1 – REPORT ADDENDUM

DEVELOPMENT APPLICATION No. X/163/2018 for the demolition of existing buildings, earthworks, construction of new place of public worship, visitor accommodation, cafe, ancillary buildings, landscaping works and car parking at 119 Cliff Drive & 34 Violet Street KATOOMBA NSW 2780

Regarding: Development Application X/163/2018 for Katoomba Christian Convention, 119 Cliff Drive and 34 Violet Street, Katoomba NSW 2780

Analysis Table Responding to BMCC's Letter 22 June 2018

Drawing Title
PLAZA ELEVATIONS

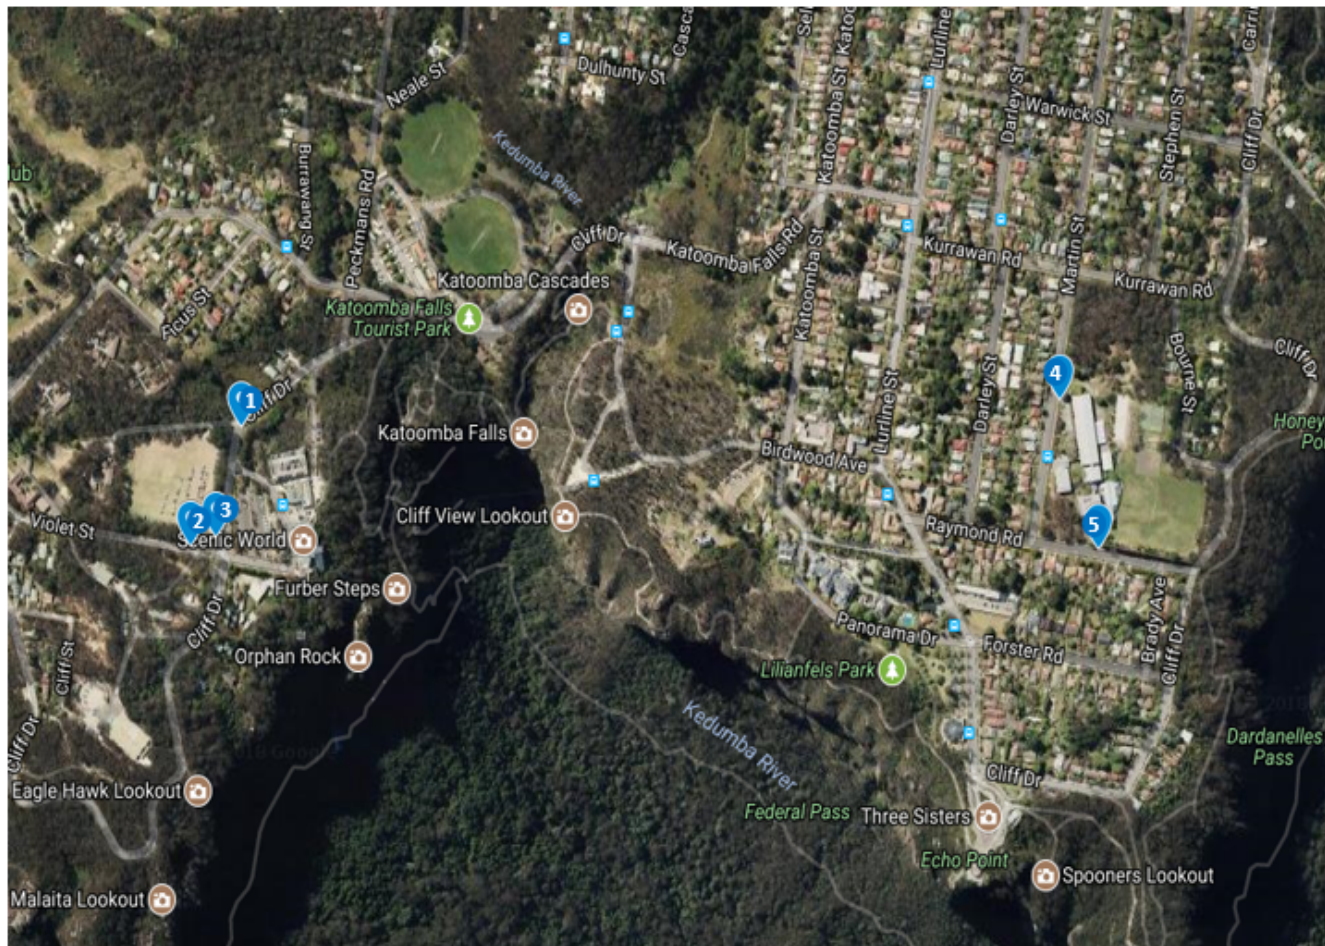
9. Pervious area The minimum area to be retained as pervious area in DCP 2015 Part B2.4 C12 is 60% of the allotment area. Precinct Control C9 in Draft Amendment 2 to DCP 2015 increases this to a minimum 70%. Table 7 on page 32 of the Statement of Environmental Effects does not provide a calculation of existing and proposed pervious area. Council's calculation of the pervious area is 20,947m² (scaling from Drawing No. 14289-008 with reference to the Landscape Plan 14289-LDA01-1) which includes the building footprints, plaza, pathways and driveways but excluding the permeable paving to the car parking spaces. This calculation indicates an impervious area of 38% of the land area, and a 62% landscaped area. Any new development proposal would need to provide a minimum 70% pervious area. This would appear achievable through a reduction in building site cover to comply with the Building Site Cover control.	This matter has been resolved. See previous comments in B6 above. The attached NBRS Site Area Map identifies 22,315m² of pervious area (40.6%) or 20,815m² (37.9%) when the gravel plaza is excluded. Summary of areas: • Site Area: 54,925sqm • Existing Site Coverage: 3,550sqm • Proposed Site Coverage: 9,383sqm • Proposed Impervious Area: 22,315sqm • Proposed Impervious Area minus gravel plaza: 20,815sqm

9. The calculation for the total proposed impervious area is requested. This needs to include building site cover as well as driveways, pathways and other hardstand areas. This will demonstrate whether or not a minimum pervious area of 60% is achieved to DCP 2015 Part B2.4 and 70% to DCP 2015 Amendment 2. <i>Council has made its own calculation at Item B9 above. Your calculations should be provided to verify.</i>	KCC considers this matter has been appropriately addressed above. Summary of areas: • Site Area: 54,925sqm • Existing Site Coverage: 3,550sqm • Proposed Site Coverage: 9,383sqm • Proposed Impervious Area: 22,315sqm • Proposed Impervious Area minus gravel plaza: 20,815sqm
